SUMMARY:

On January 17, 2013, the County Development Review Committee (CDRC) met and acted on this case, the decision of the CDRC was to recommend approval of the Applicant's request, for Master Plan and Preliminary Development Plan with staff conditions and to allow Final Development Plan to be approved administratively. The CDRC also recommended approval of a variance of Article III, § 4.4.3c (Parking Lot Location) to allow the parking lot to be located in front of the proposed building and a variance of Article VIII, §'s 7.3, 7.8 and 7.14 (Design Standards for Permanent Signs) to allow a sign to exceed the height and set back requirements and to allow a wall mounted sign to exceed 70 square feet in sign area. The CDRC recommended that the building mounted sign be reduced from the proposed 174 square feet to 105 square feet in sign area and that the free standing sign would not exceed 12 feet in height. The Applicant agreed to the conditions of approval.

Master Plan and Preliminary Development Plan approval for an 8,320 square foot structure to be utilized as a Family Dollar Store on 0.87 acres and Final Development Plan to be processed administratively.

RE: Preliminary Develo

TERRAIN MANAGEMENT / GRADING & DRAINAGE PLAN

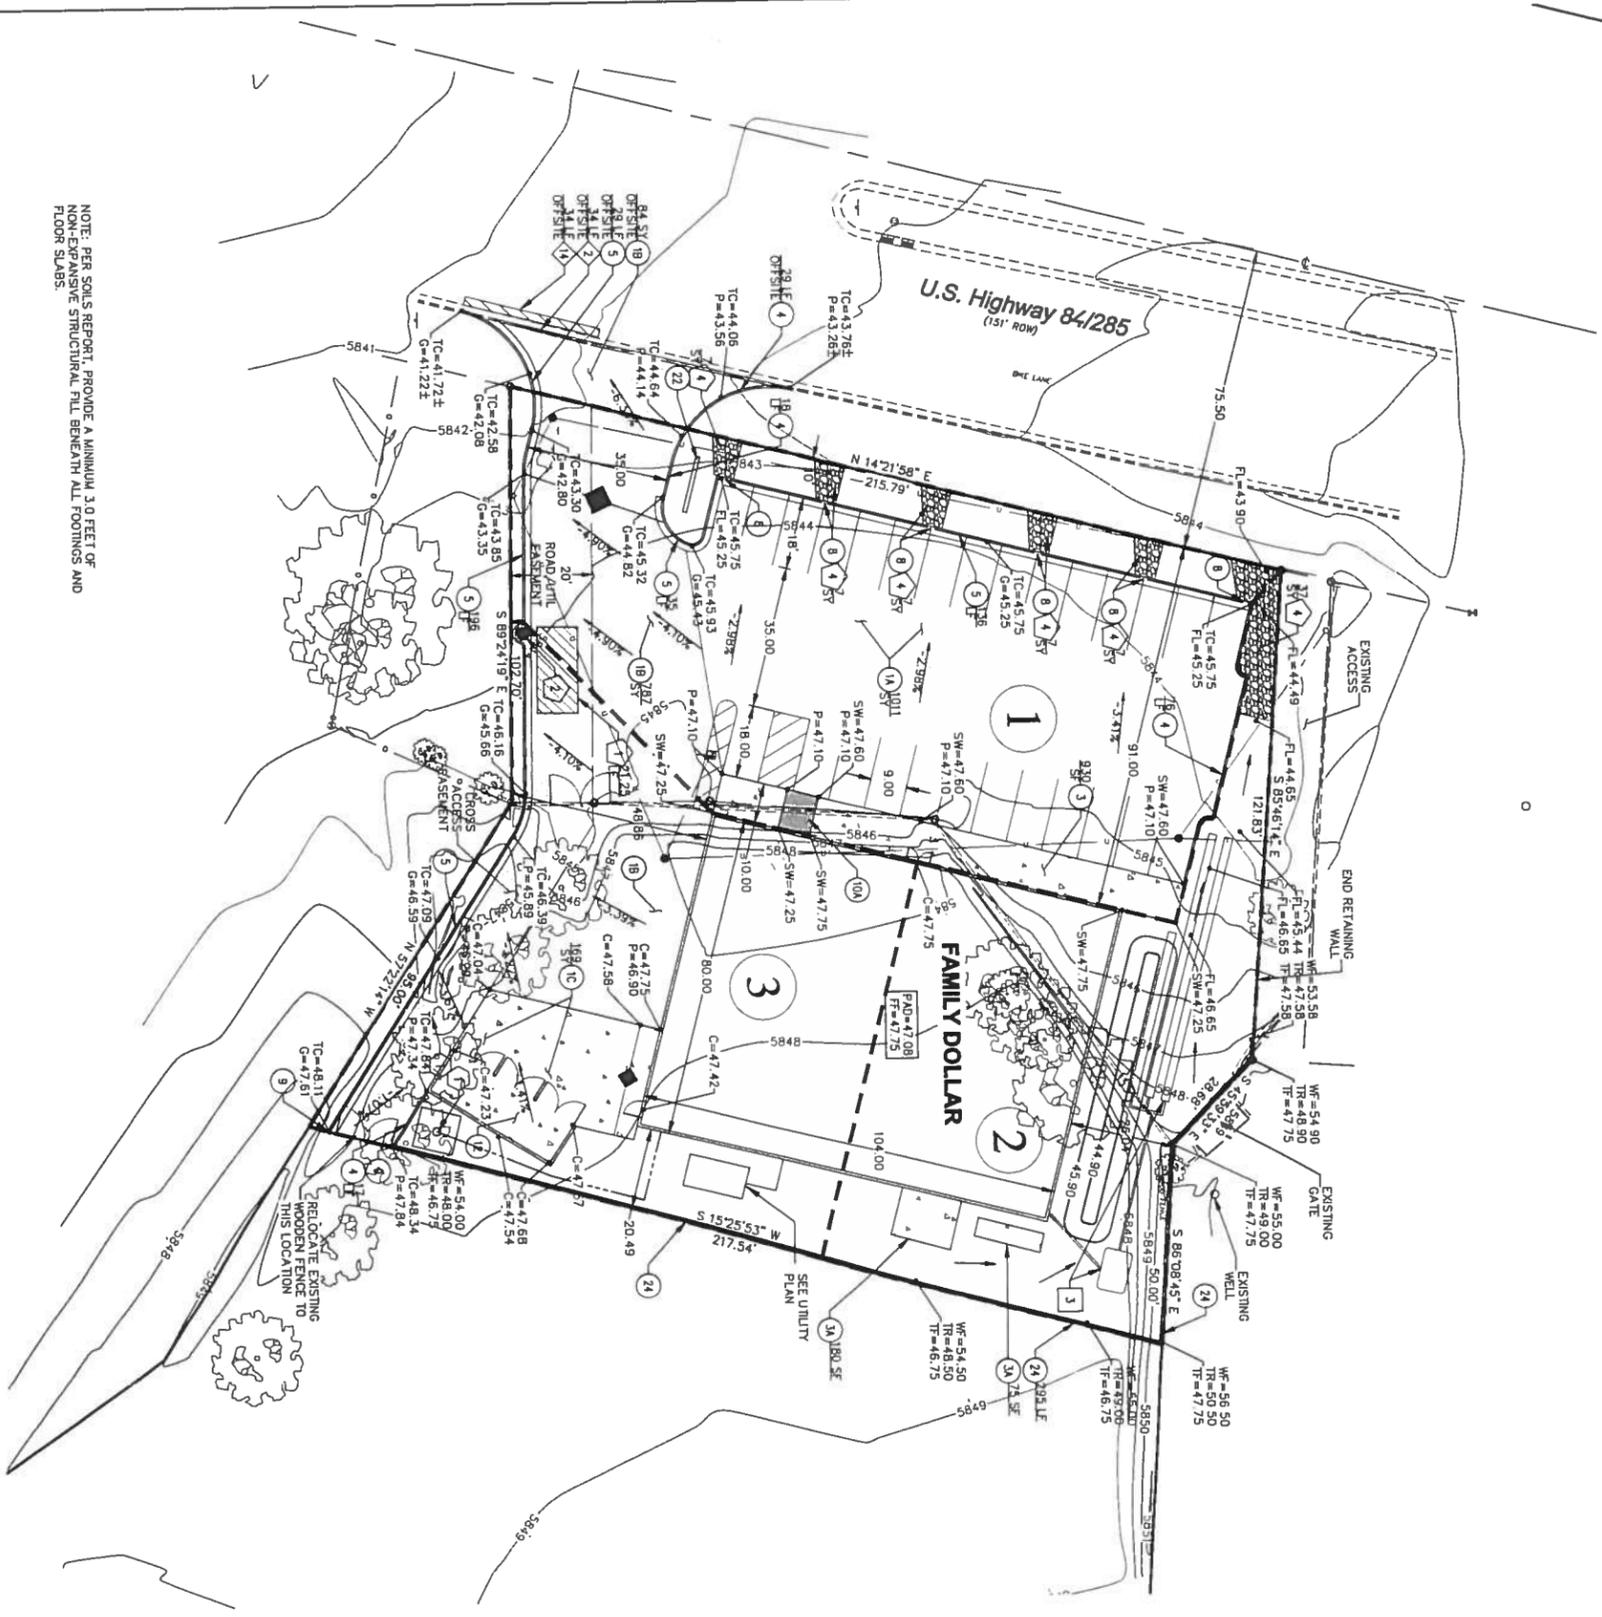
However, the proposed plan indicates that the western portion (sub-basin 1) of the property and all impervious surface runoff will be retained with tree wells. The post runoff coefficient for (sub-basin 2) NE is retaining a total of 513 CF. The proposed pond capacity for the NE Pond is 580.09 CF. The site also contains a holding tank that will capture runoff from sub-basin 3 and is located on the southern boundary of the property. The volume provided is a total of 1,668.97 cf and incorporates the runoff from a portion of the roofed structure. There are no drainage calculations designated for roof runoff and site runoff. Therefore, the proposed plan does not meet the requirements of the Santa Fe County Land Development Code, and Ordinance 2008-10 Flood Damage Prevention and Stormwater Management Ordinance.

The Applicant shall provide calculations for Sub-Basin 3 for roof runoff and impervious surfaces to ensure adequate retention for both roof and impervious surface runoff.

The Applicant shall provide calculations and ponding details for the tree wells to insure adequate retention for Sub-Basin 1

1 ELECTRICAL SITE PLAN

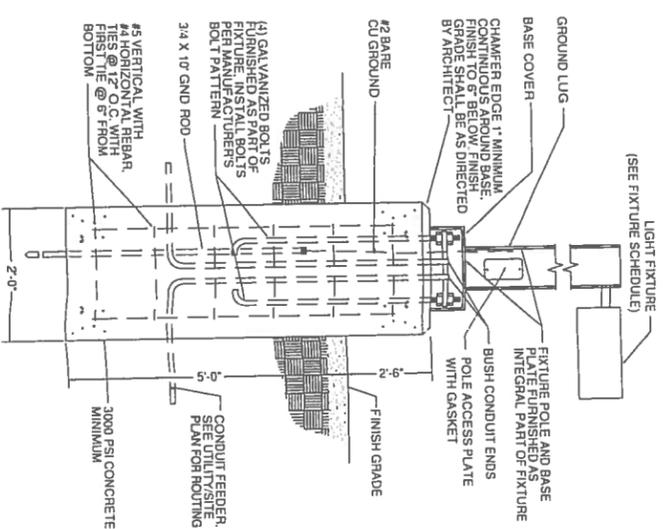
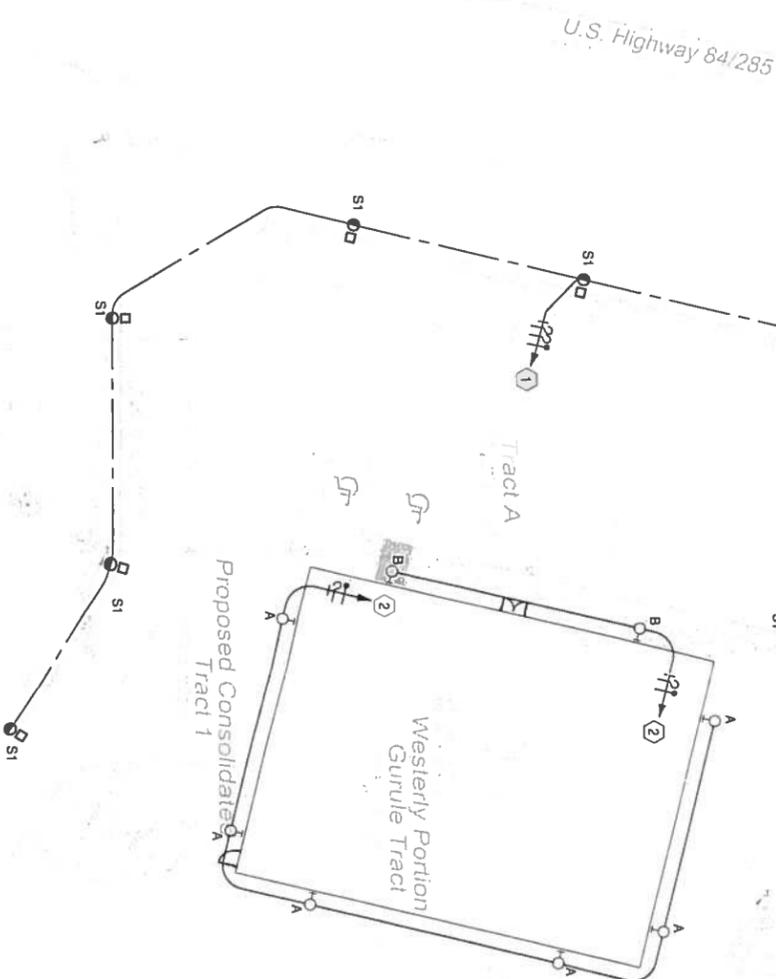
The Applicant proposes to utilize 7 Pole Mounted lights in the parking lot. The Applicant shall provide scaled height dimensions for the pole mounted lights as well as cut sheets. The Applicant shall provide cut sheets for illumination of signage. The Applicant proposes to utilize 8 building mounted lights, cut sheets shall be provided. Staff has determined that the lighting element of the Application is incomplete per Article III, Section 4.4.4 h

and Table 3.1. The Applicant shall submit revised plans addressing deficiencies at Final Development Plan.

G PREFERRED PYLON SIGNAGE
DOUBLE FACE PYLON OPTIONS

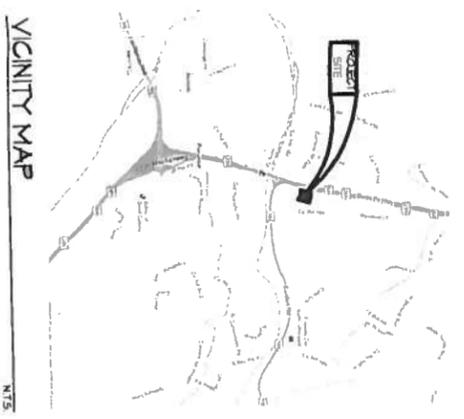
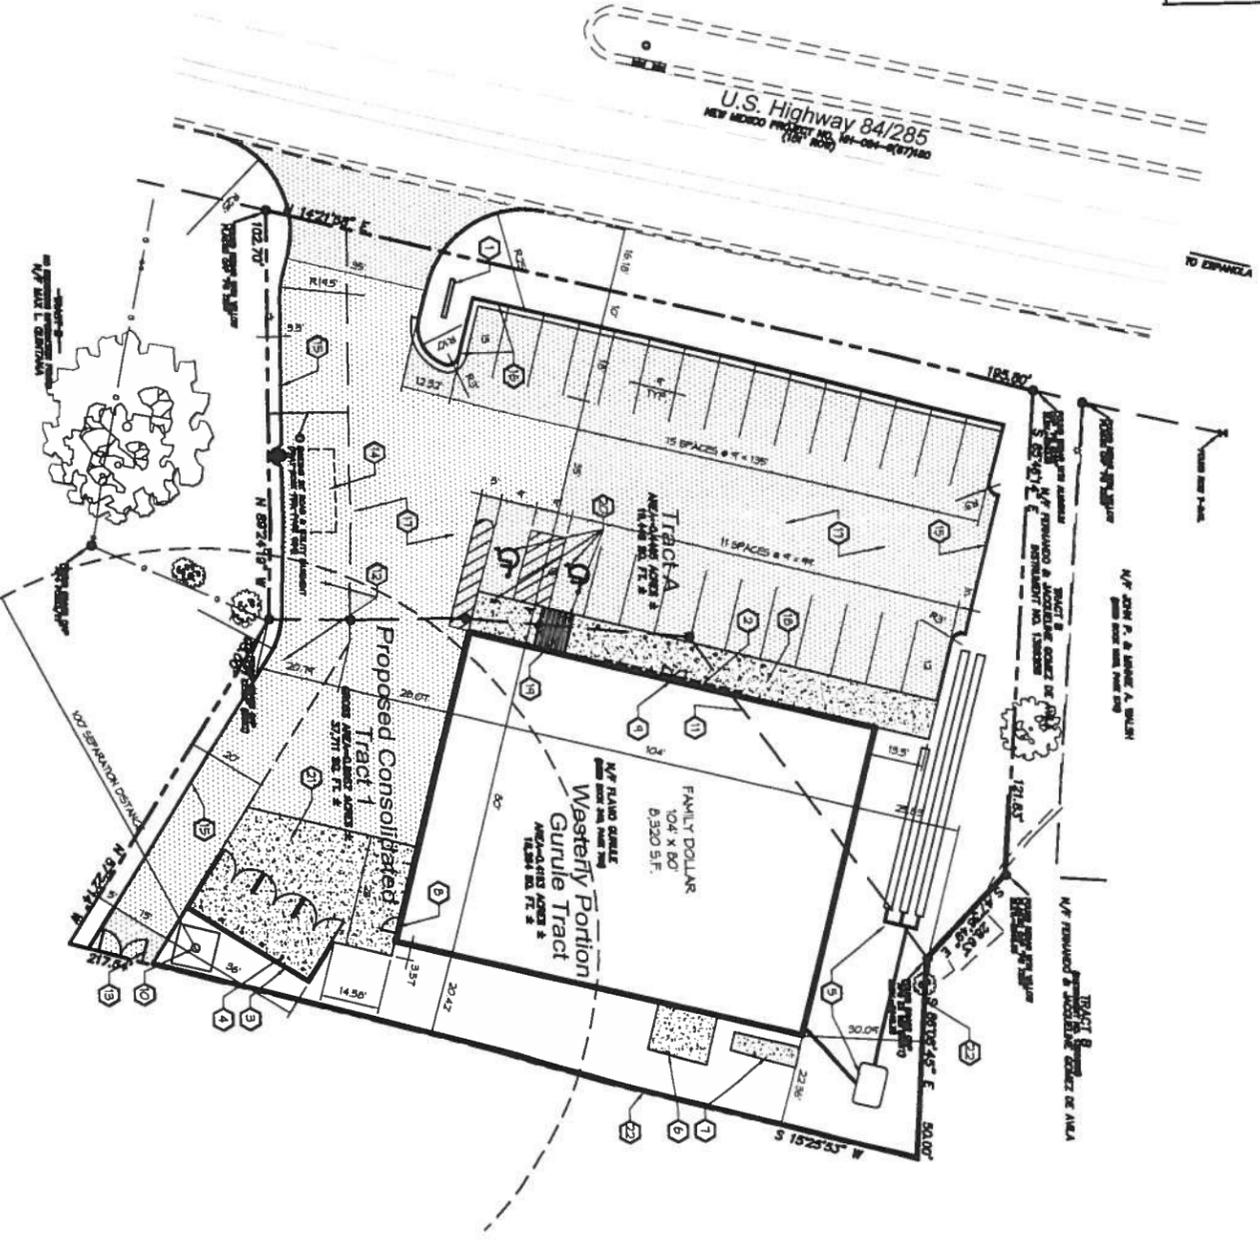
Article VIII § 7.3.a (Height and Setback Standards) states: “the maximum allowable sign height for a free standing sign located at the front property line is five (5) feet. Sign height may be increased a maximum of five (5) feet in height for each twenty-five (25) feet the sign is set back from the front property line. Maximum allowable sign height shall not exceed twenty-five (25) feet”. A sign 20 feet in height requires a setback of 75 feet from the property line. A sign 12 feet in height requires a setback of 35 feet from the property line.

Article III § 7.9.b states: “a wall or building mounted sign shall in no case exceed ten (10) percent of the area of the wall on which it is displayed or seventy (70) square feet in sign area whichever is less”. The proposed 174 square foot wall mounted sign exceeds the requirements of the Code by 104 square feet.

The Applicant has requested variances for a free standing sign and a wall mounted sign. The proposed height of 20' ft. for the free standing sign must allow for a 75' ft. setback, and shall have a banco, planter or a low wall compatible and complimentary to the building or premises and/or shrubs, flowers or a groundcover. The free standing sign request does not conform to Article VIII, Section 7.3 and 7.8. The wall mounted sign exceeds 70 sq. ft. maximum area. The proposed wall mounted sign area is 174 sq. ft. The proposed wall mounted sign does not conform to Article VIII, Section 7.14.
